TOWN OF BAY HARBOR ISLANDS PLANNING AND ZONING BOARD

April 17, 2018

Subject: Site Development Plan Application – Revision #1
Atlantis of Bay Harbor – 28 DU Multi-Family Residential Complex
10281 West Bay Harbor Drive
Bay Harbor Islands Acct. No. MB2017-21
MMPA Acct. No. 01-0702-1049

Below are all of the changes since the PZ Board approved the plans on March 21st, 2017:

DRAWING TITLE
**LEVEL 6
FLOOR PLAN**
SCALE: - DATE: APRIL 3, 2018
SHEET NUMBER
A-106
P&Z REVISIONS

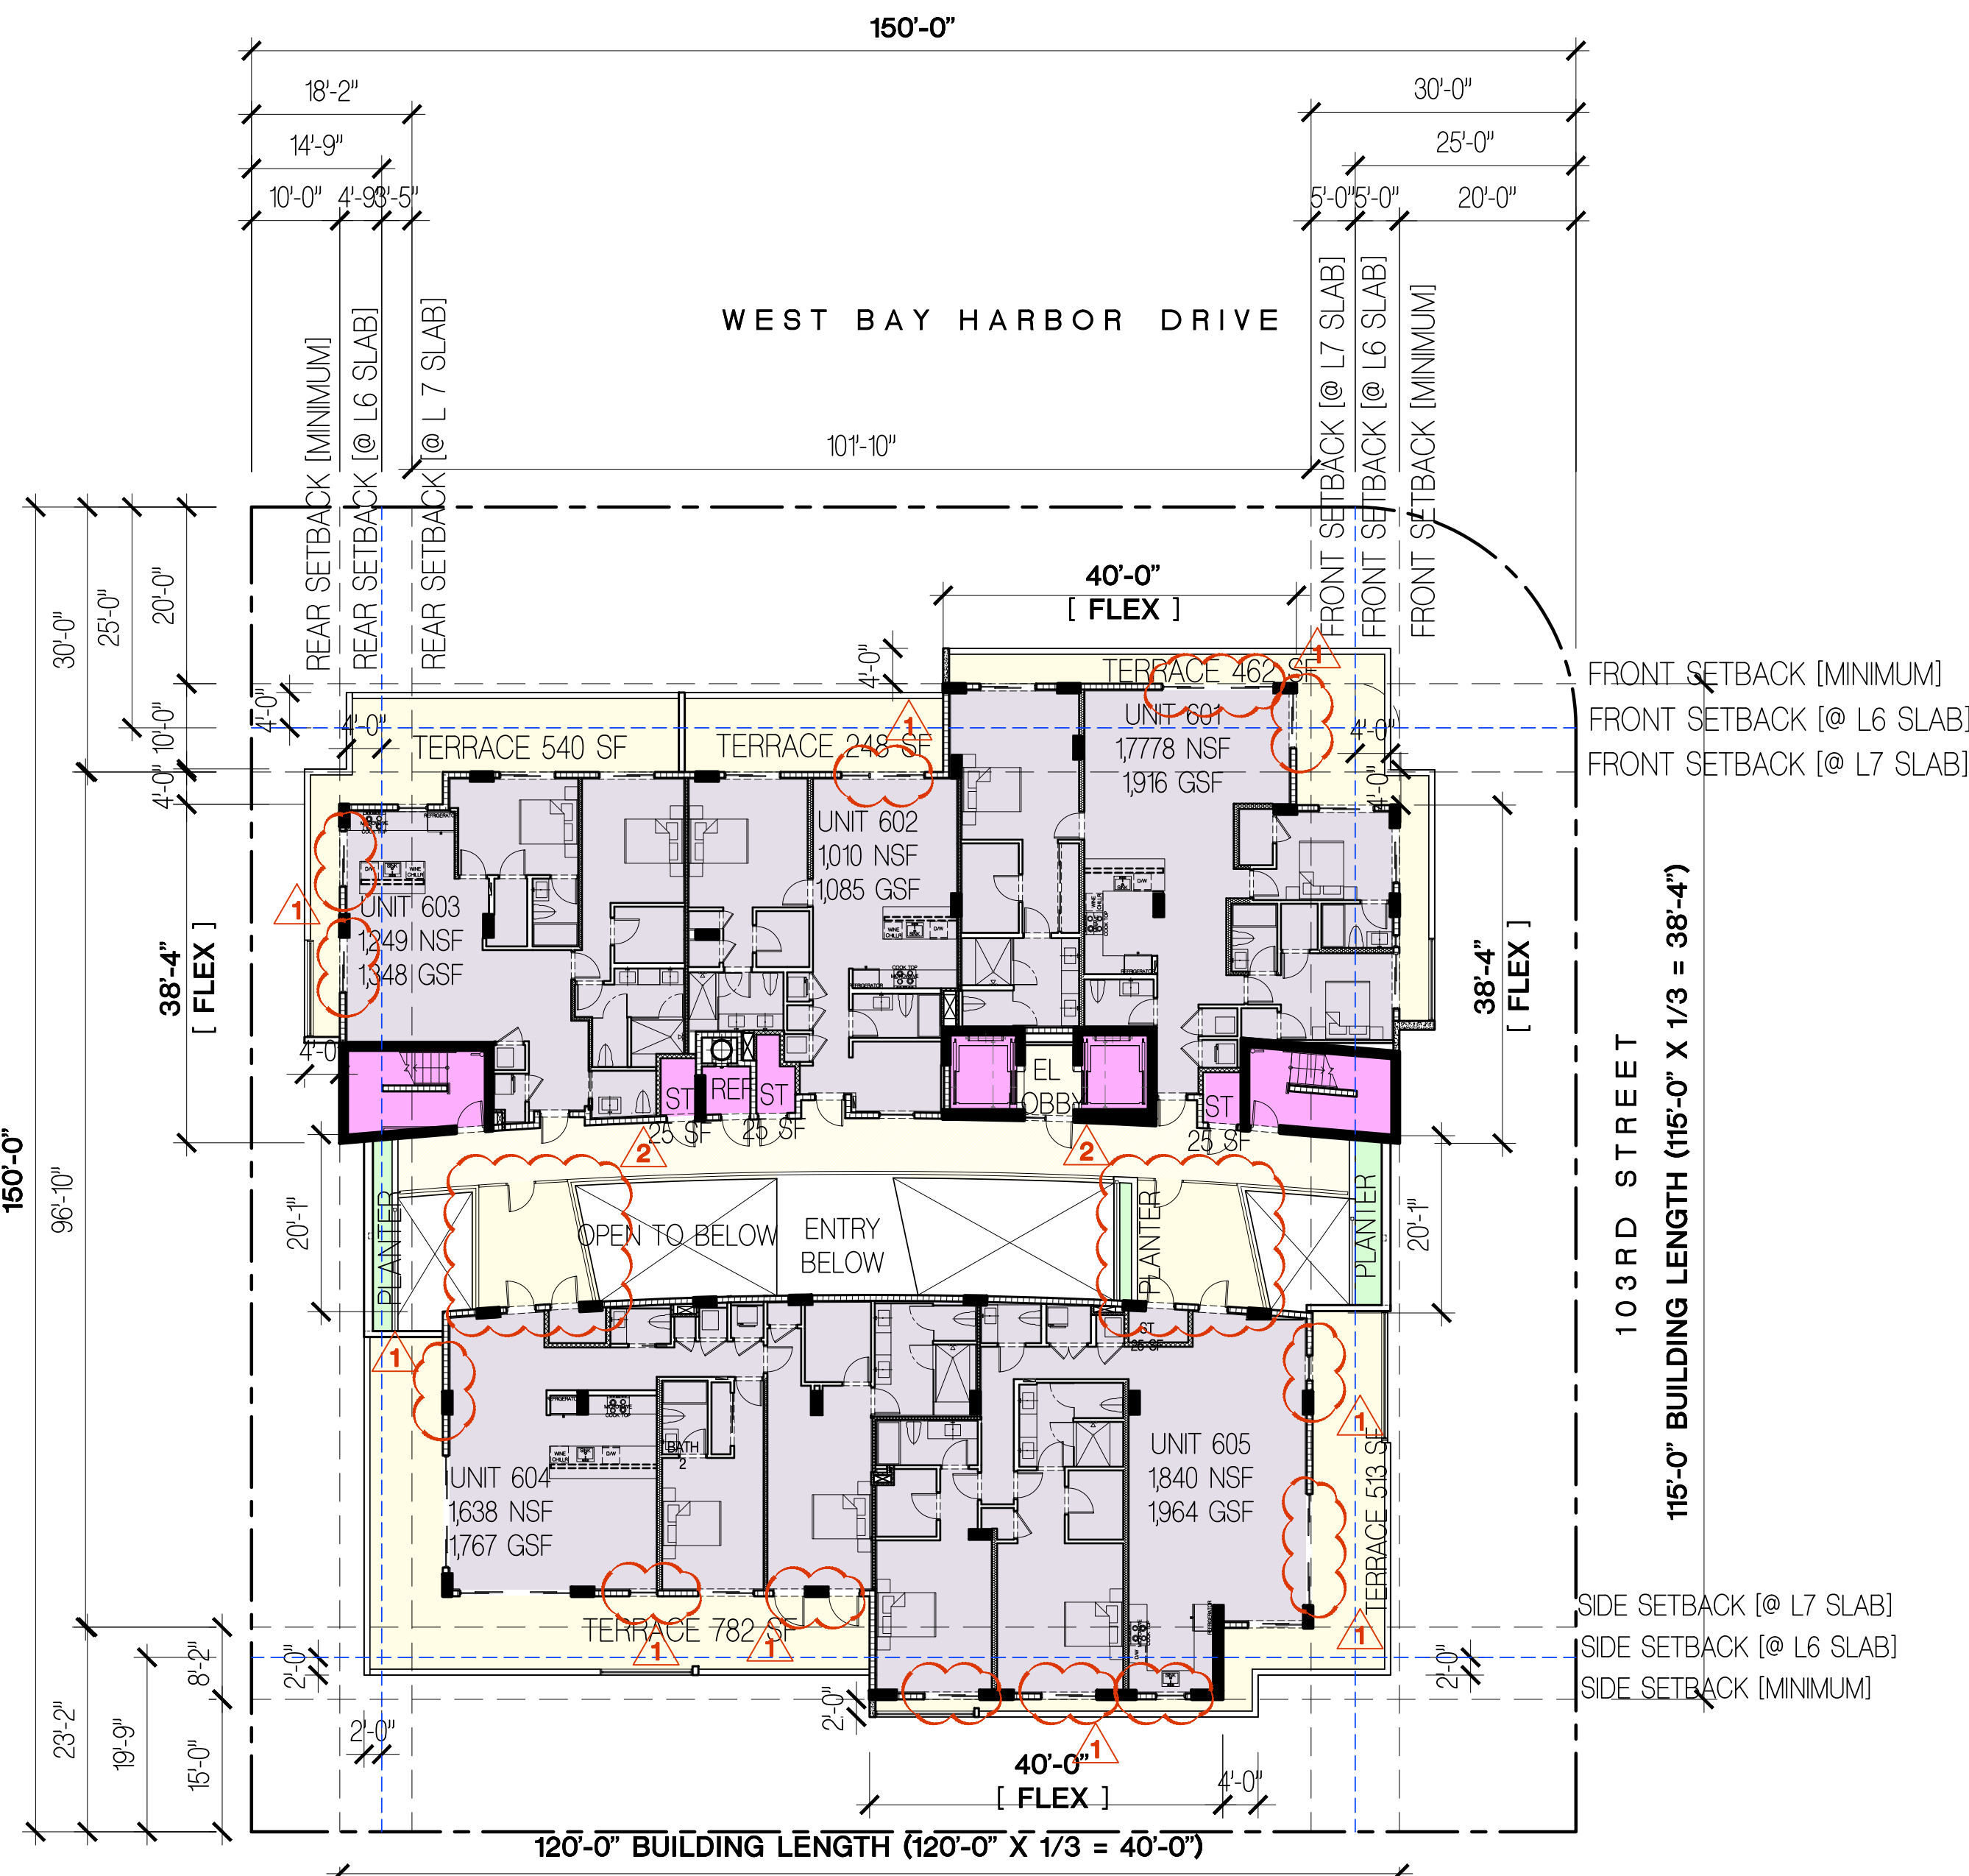
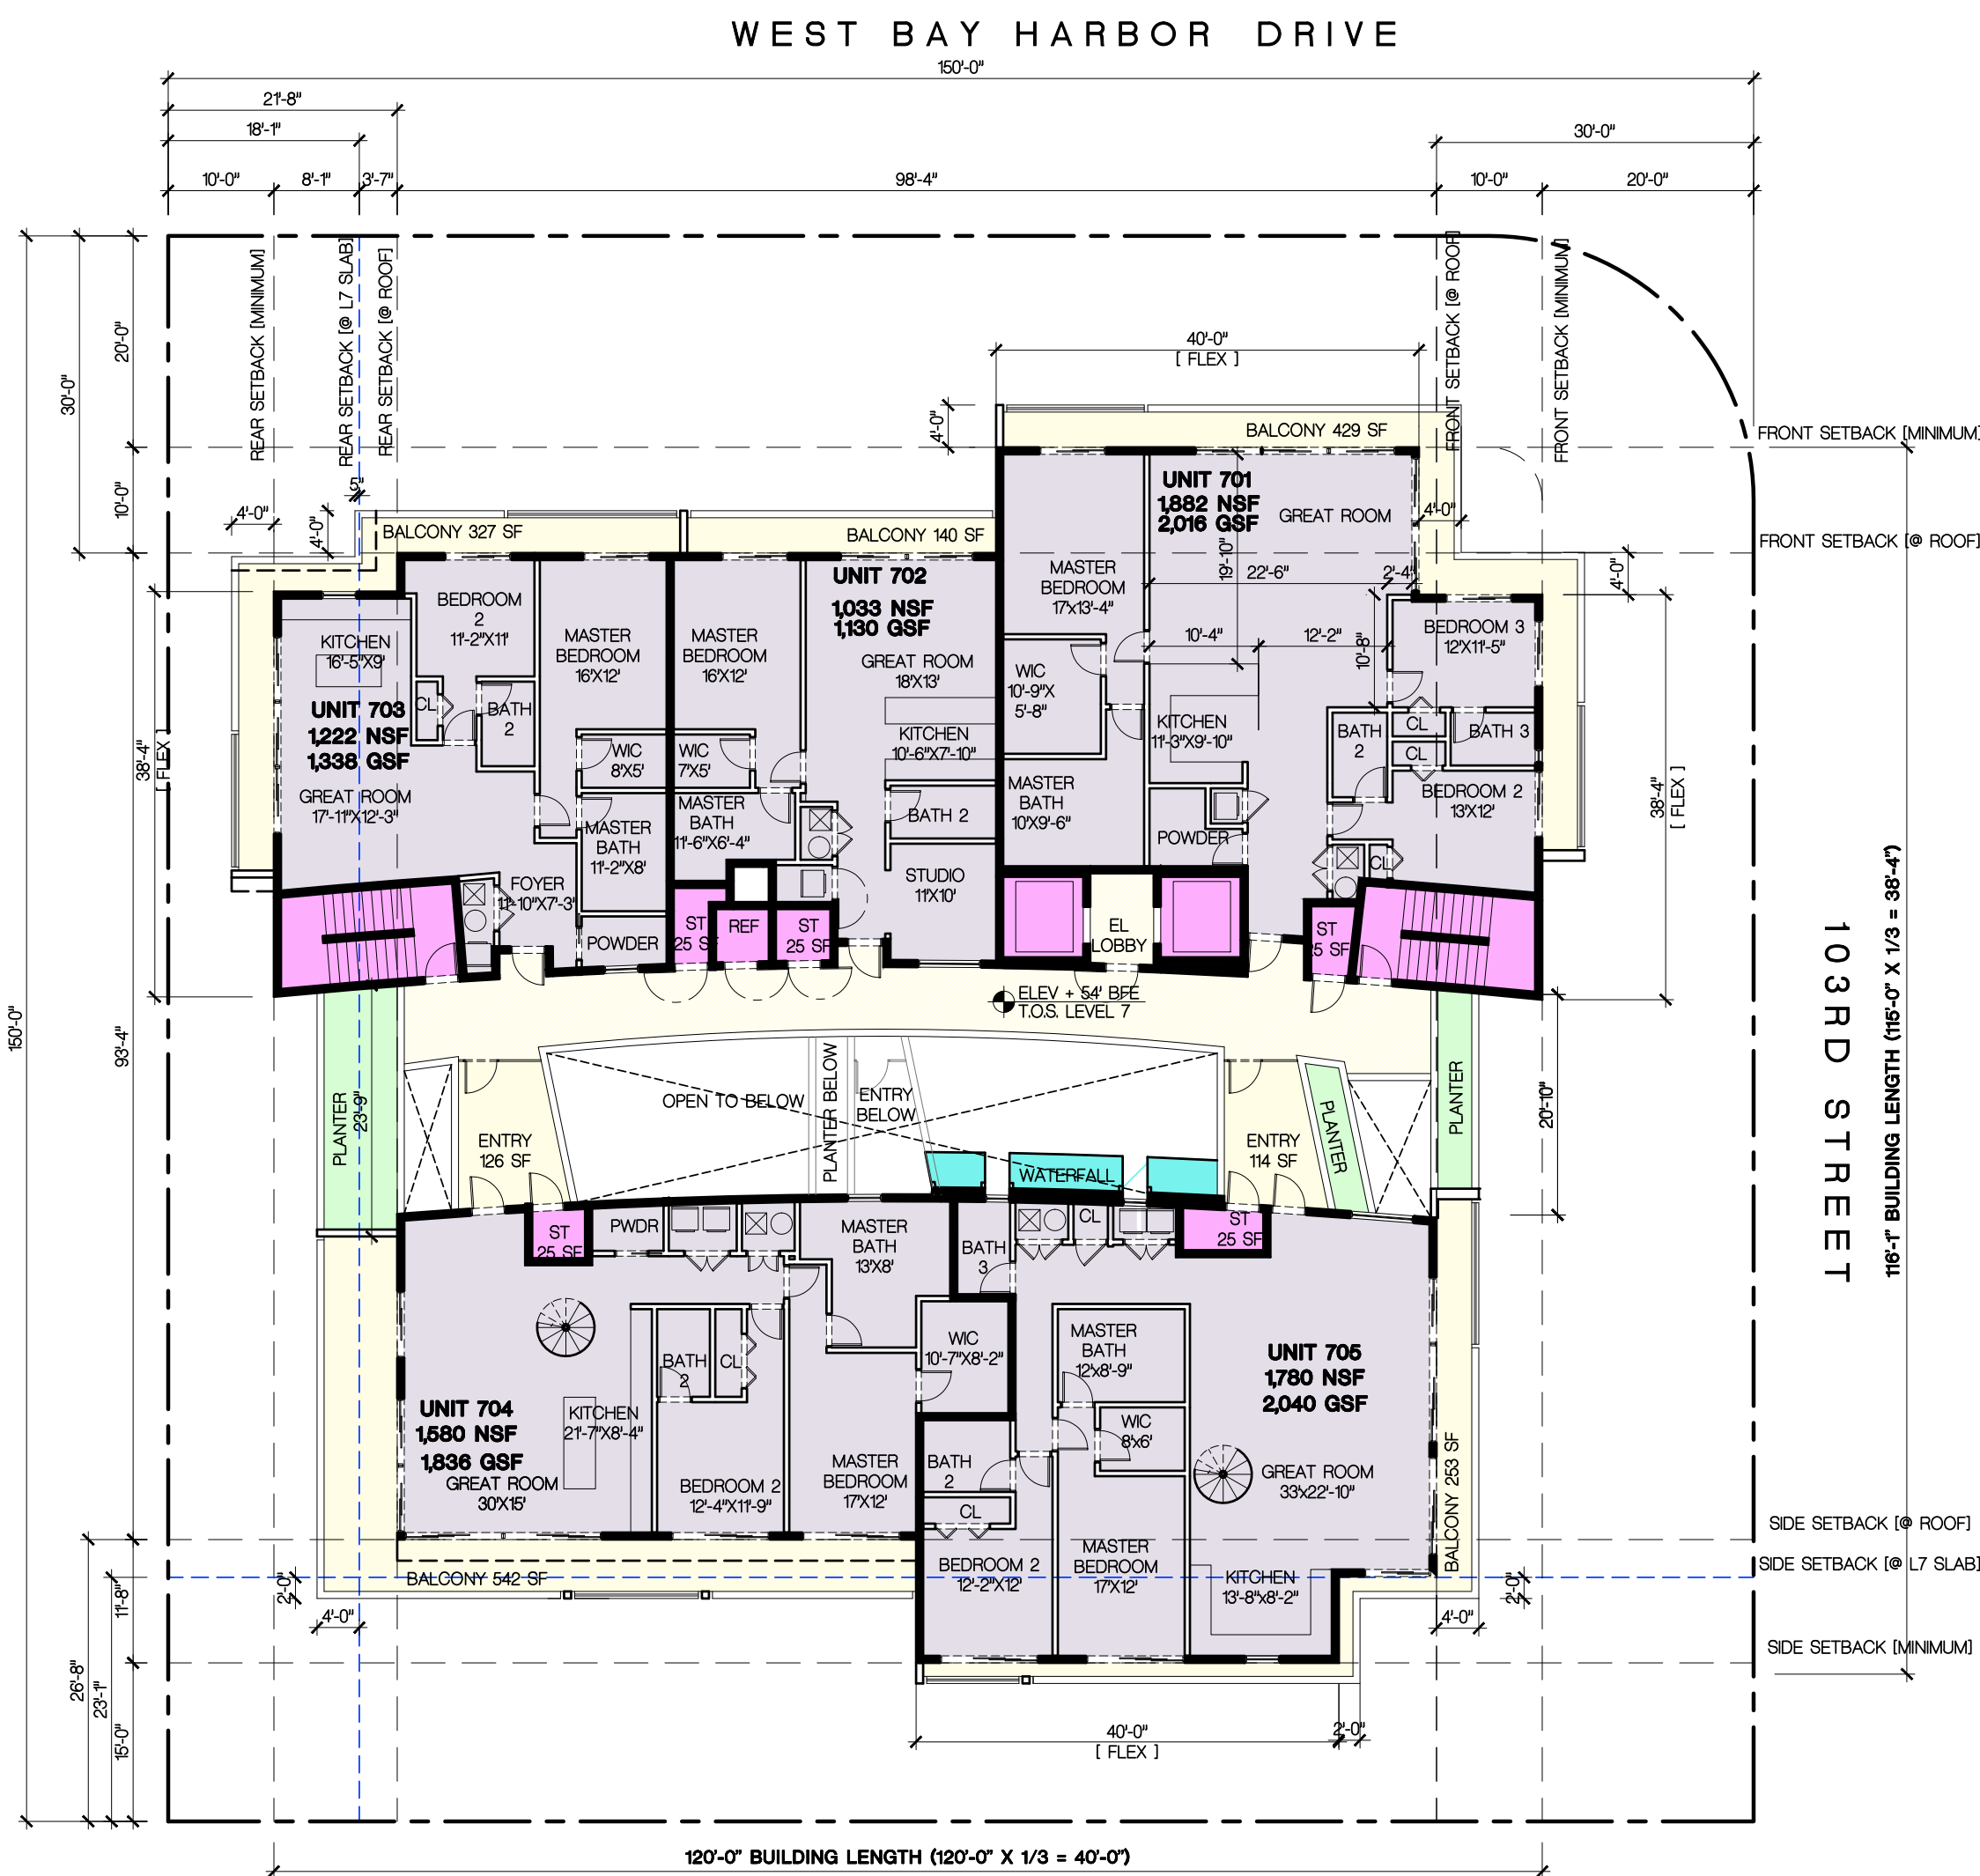
-  **REDUCED GLAZING ALONG THE EXTERIOR PERIMETER**
-  **INCREASED THE AREA OF THE 3 PRIVATE ENTRY COURTS TO THE NORTH UNITS.**
